TOWN OF WEST WARWICK
REQUEST FOR PROPOSALS (RFP)

GENERAL CONTRACTOR
30 Payan Street Renovation

ADDENDUM #2
Posted 2/12/2026

RFQ/P REFERENCE NUMBER: 2026-08
RFP RELEASE DATE: January 27, 2026

A2.30

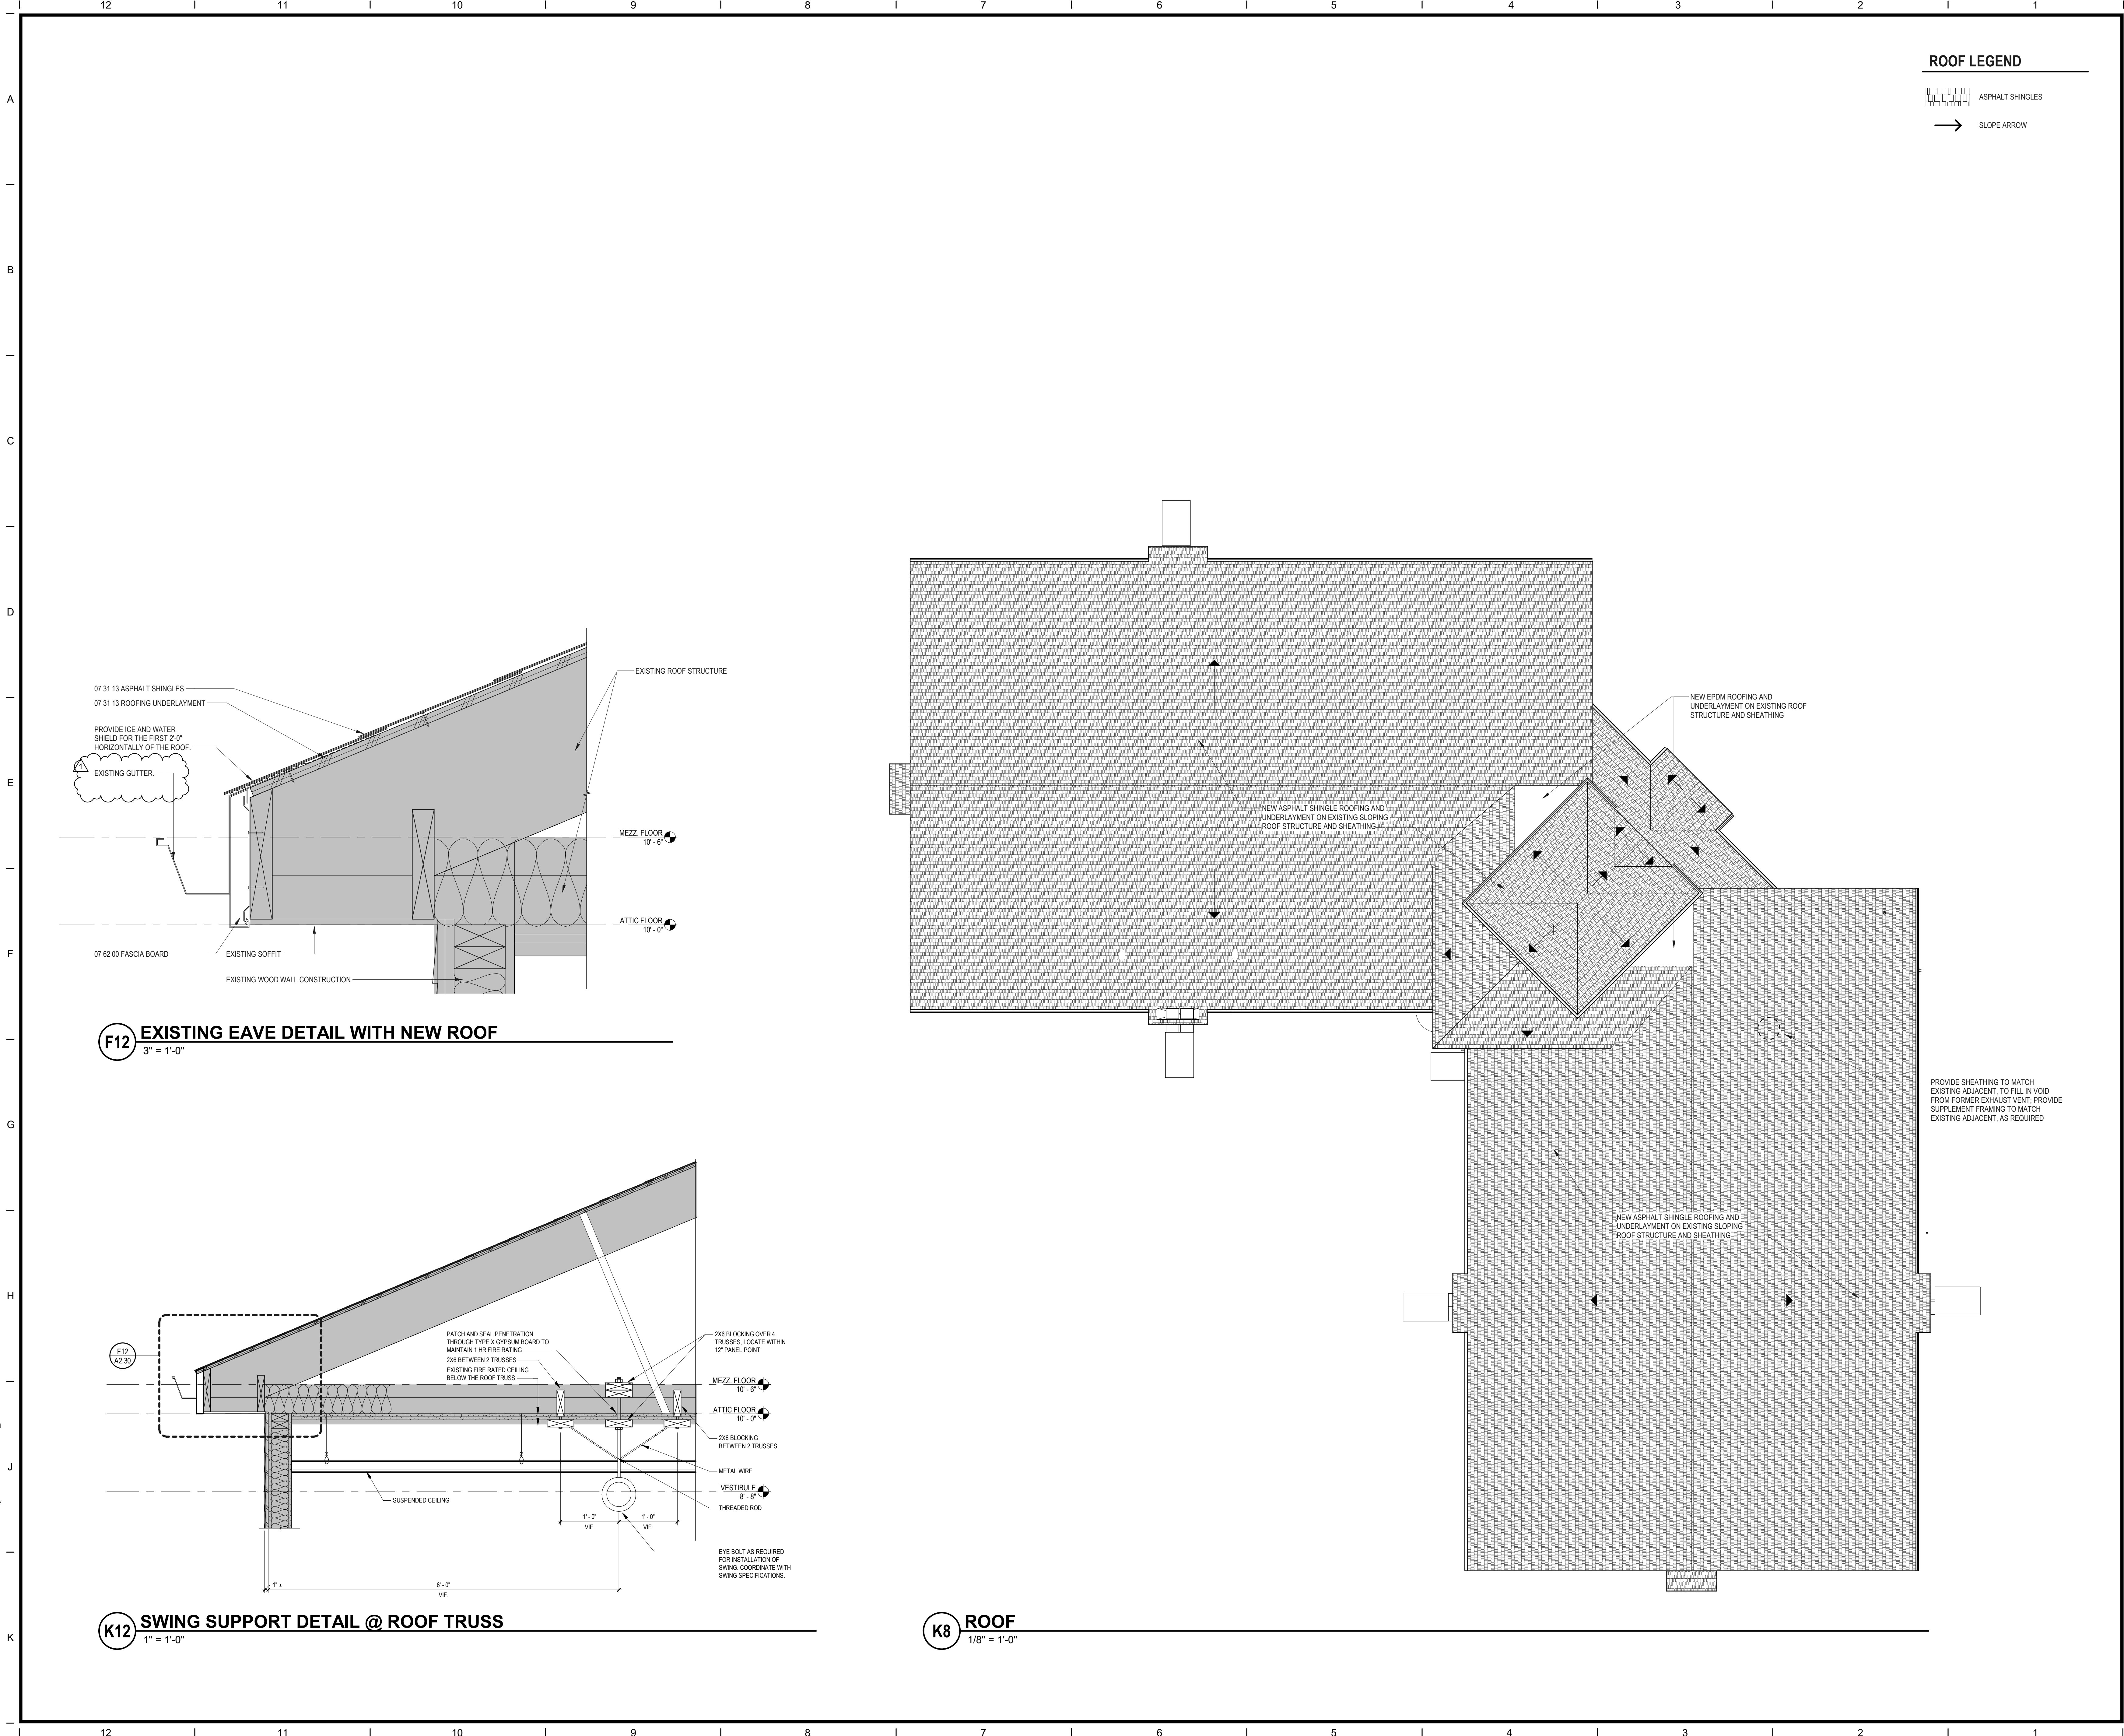
- Coordinated slab infill with plumbing and electrical drawings per RFI A-01.
 5. A2.30 ROOF PLAN & ROOF DETAILS
 - Added a note on drawing F12 to indicate that all gutters are to remain existing per RFI A-14.

K7 FIRST FLOOR REFLECTED CEILING PLAN

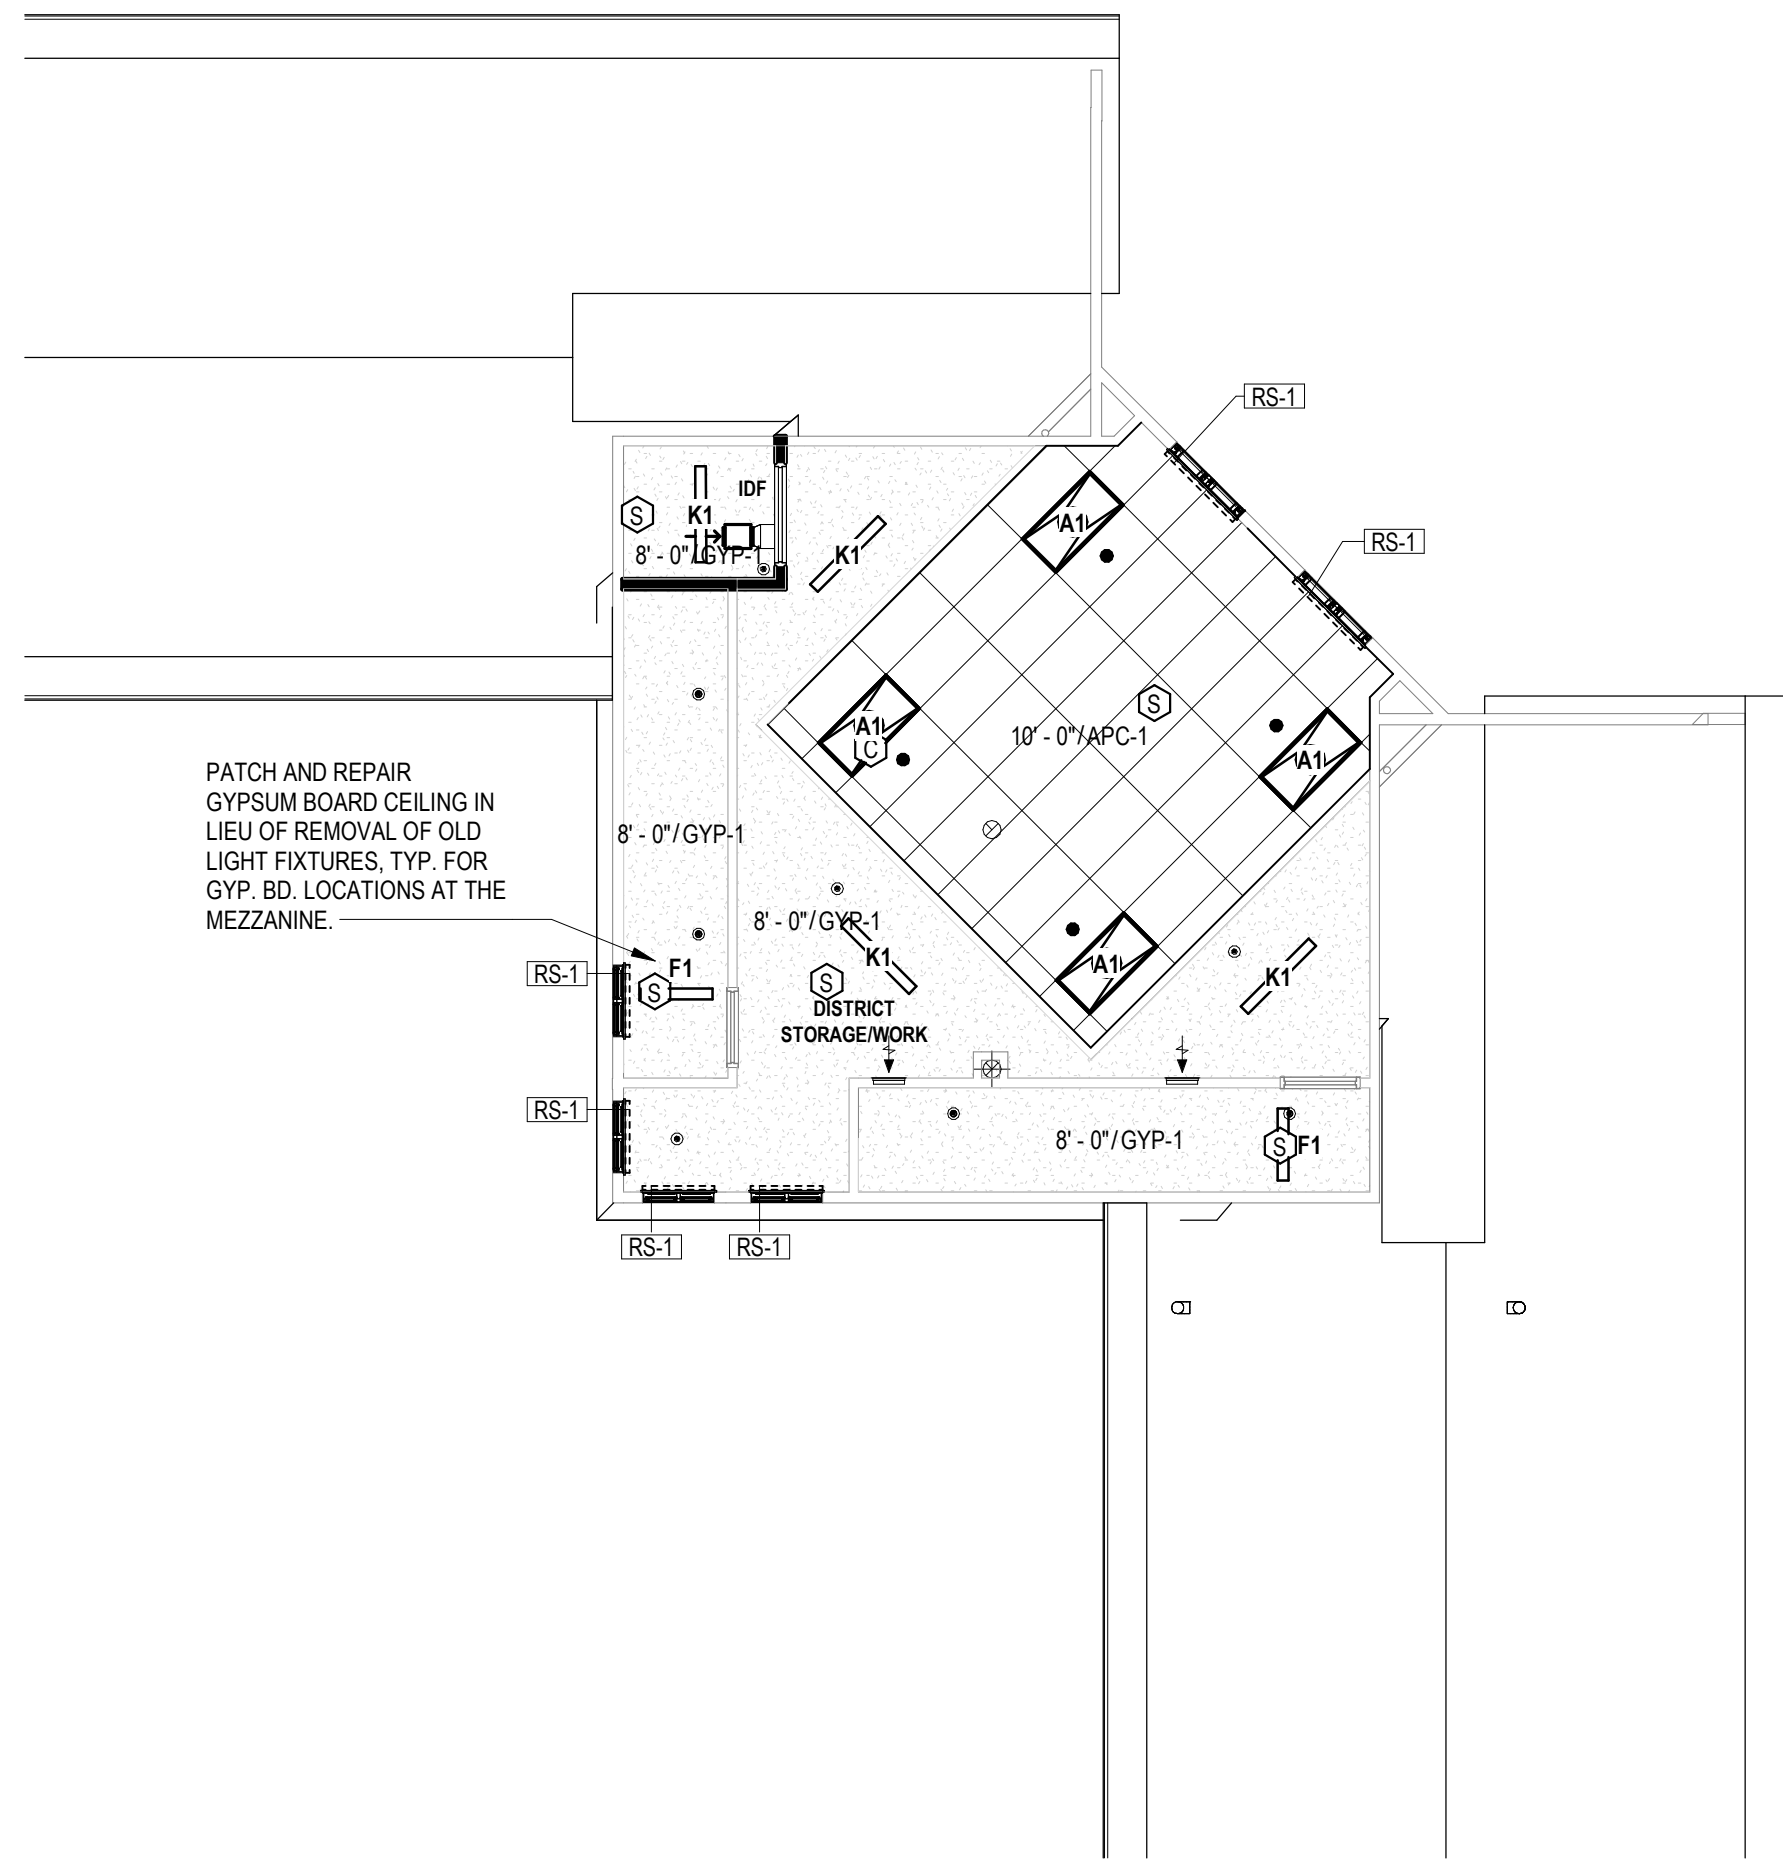
6. A3.10 REFLECTED CEILING PLANS & DETAILS
 - Updated the reflected ceiling plan to include window and roller shade tagging for rooms 102, 109, 125, and 126 per RFI A-21.

G10 BREAK ROOM - WEST
1/4" = 1'-0"

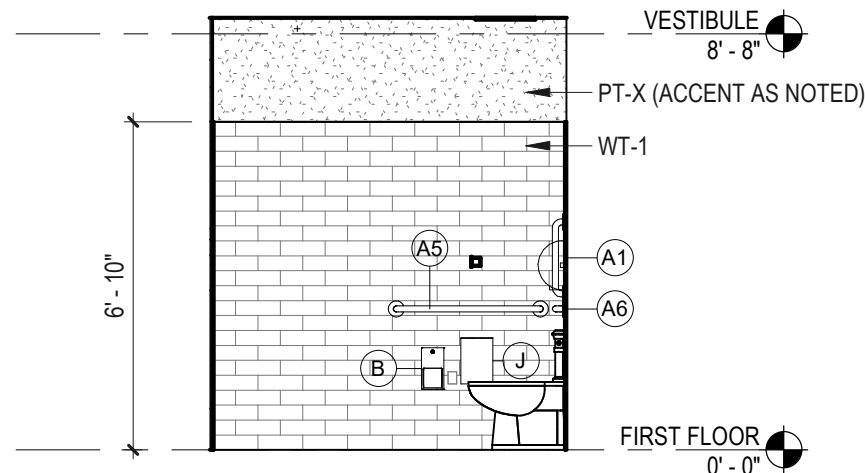
7. A6.10 ENLARGED PLANS & ELEVATIONS
 - Revised the appliance schedule and updated dishwasher tagging on G10 to indicate the dishwasher will be owner-provided per RFI A-03.

SF HEAD AT EXIST. INT. PARTITION

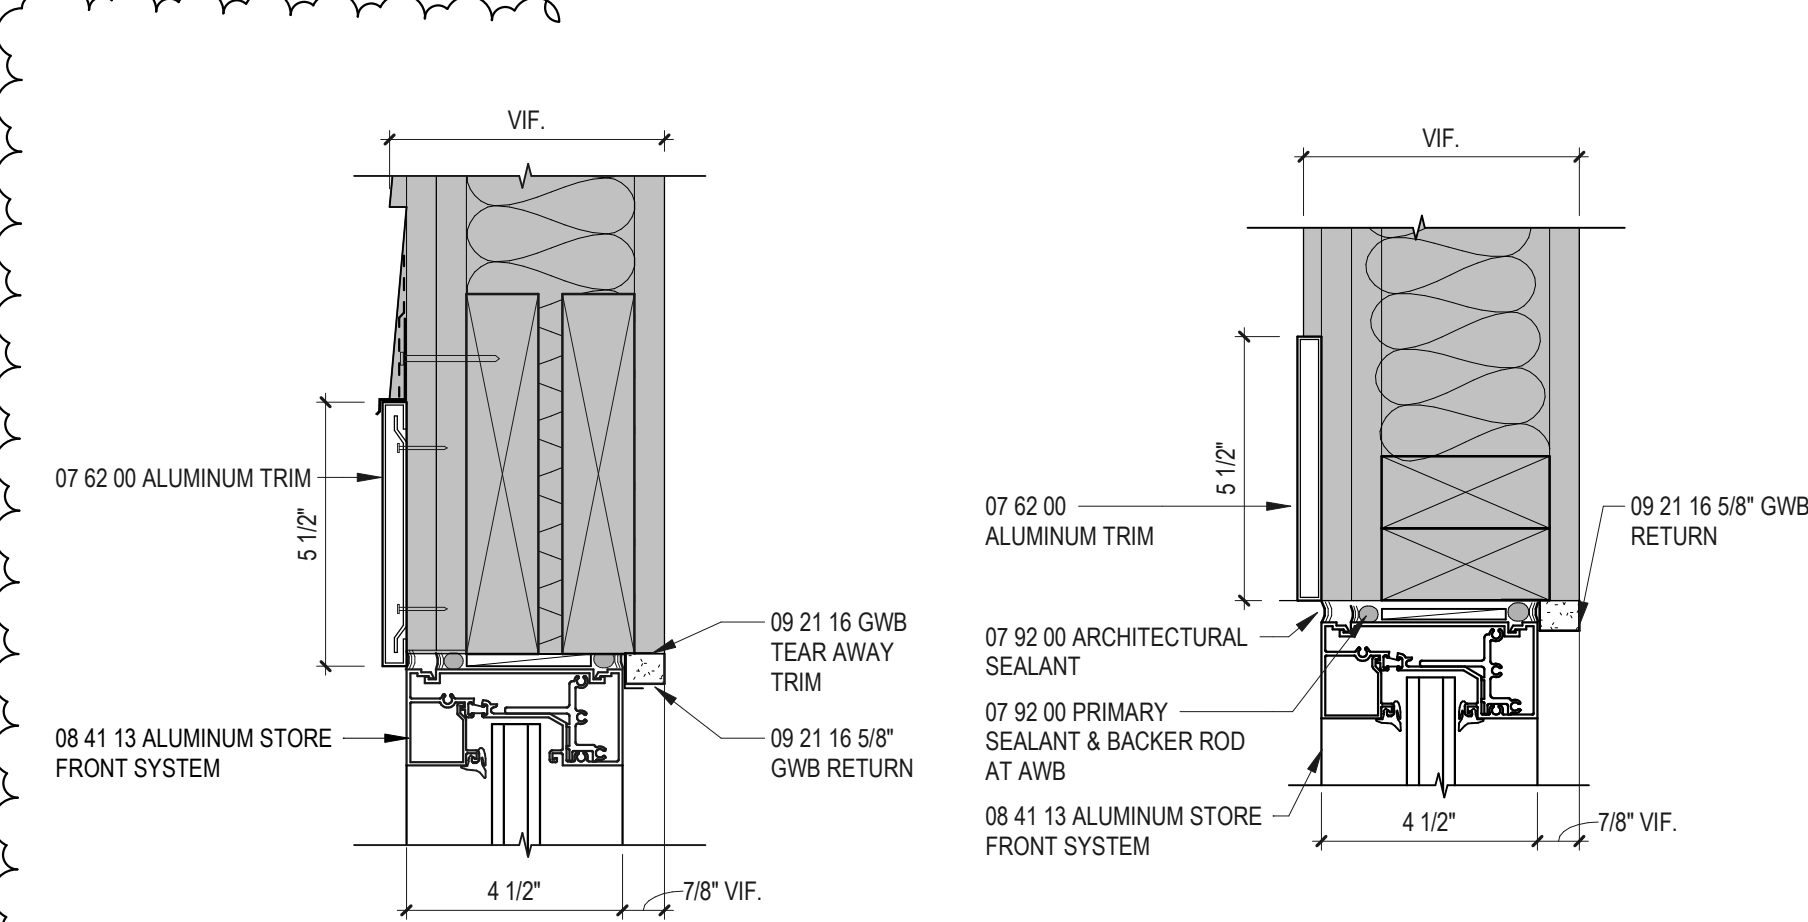
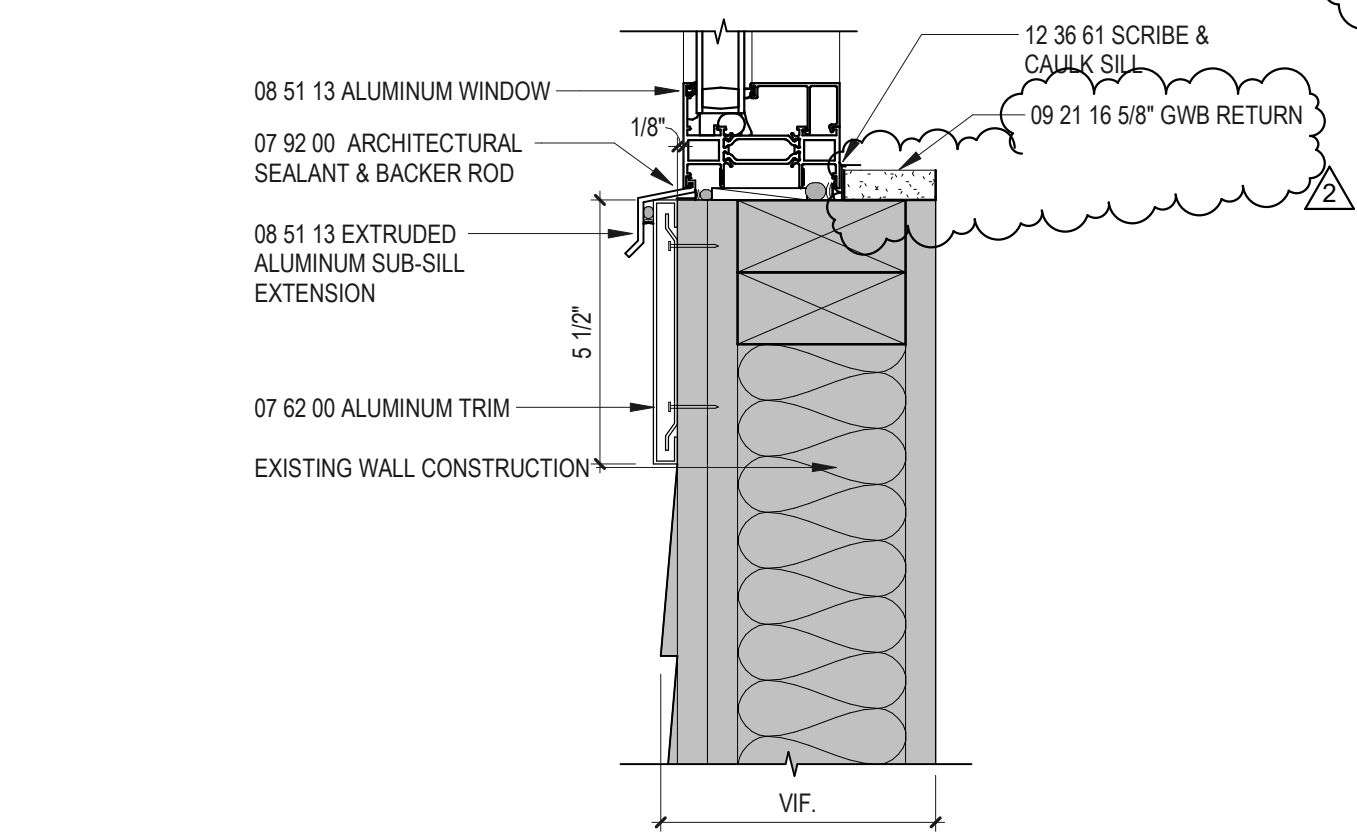
- Modified windowsill from solid surface to gypsum board return per RFI A-11.
 - Added storefront jamb detail at D7 and head detail at D9 for existing interior partition wall.

F8

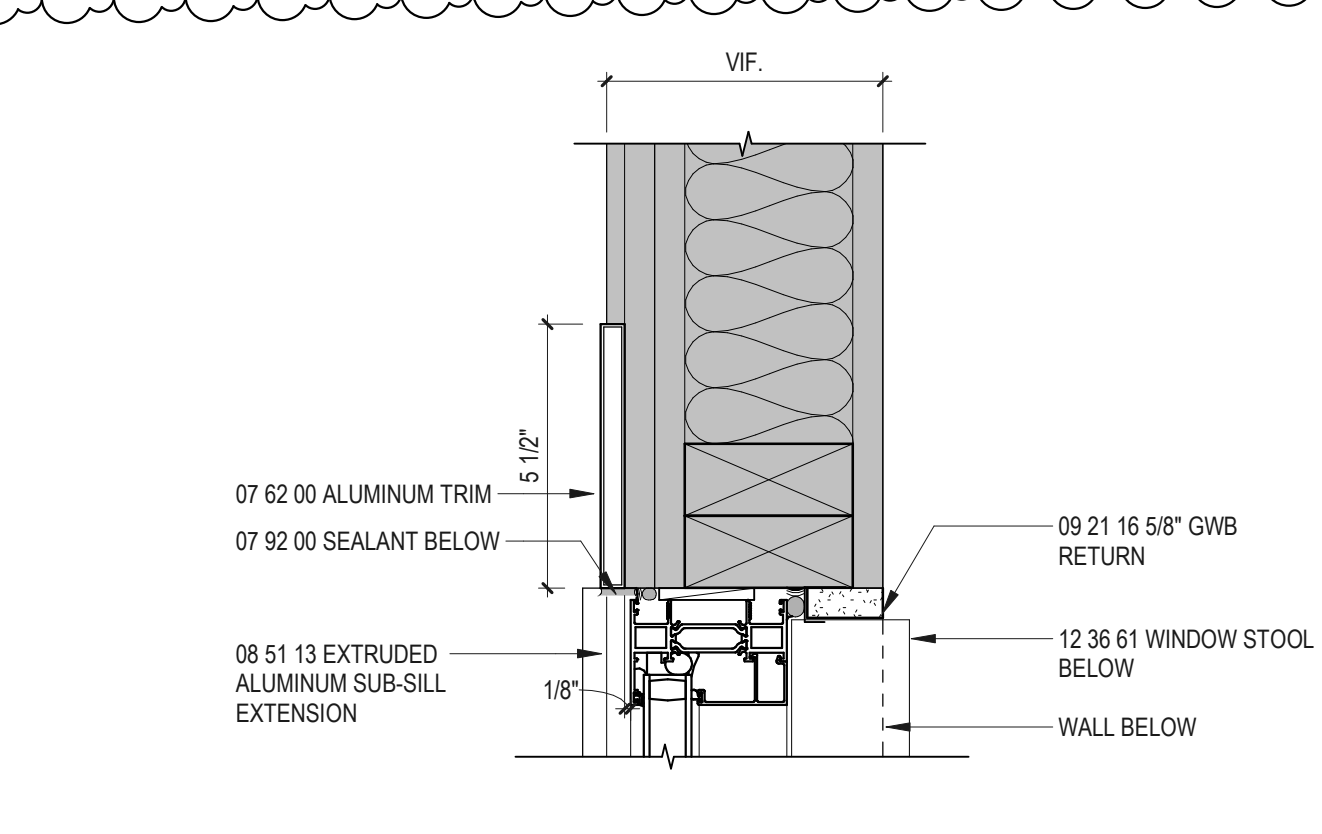
- Added storefront jamb detail at F8 and head detail at F10 for existing exterior wall.
 - Referenced storefront jamb and head details at SF1 and SF2.
 10. I2.10 FINISHED PLANS & MATERIALS LIST
